channel obsticles

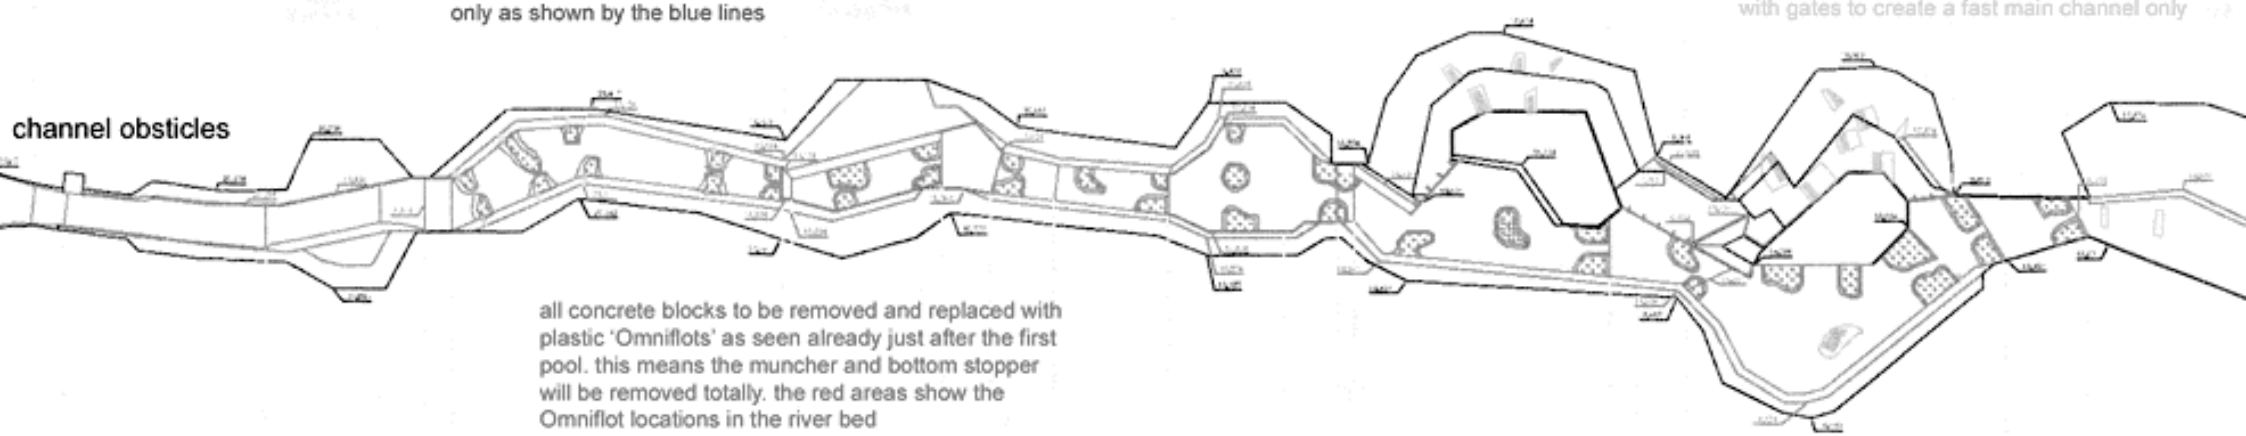
sides of the first pool and cheese block pool to be brought in to create a fast narrow channel only as shown by the blue lines

the dog leg by the muncher is to be half removed to make way for increased eddies

the chicken shoots are to be blocked off with gates to create a fast main channel only

all concrete blocks to be removed and replaced with plastic 'Omniflots' as seen already just after the first pool. this means the muncher and bottom stopper will be removed totally. the red areas show the Omniflot locations in the river bed

river bed profile

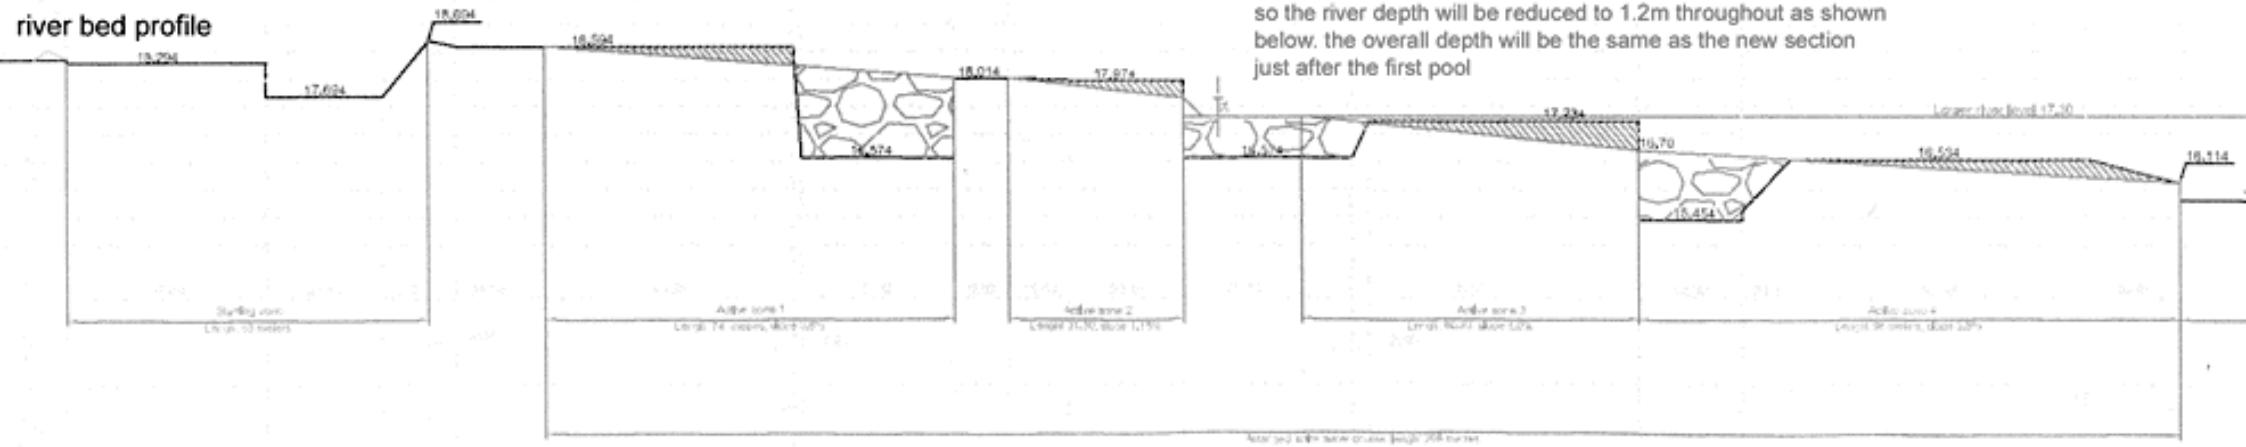
the deep pools in the course are to be filled in with concrete so the river depth will be reduced to 1.2m throughout as shown below. the overall depth will be the same as the new section just after the first pool
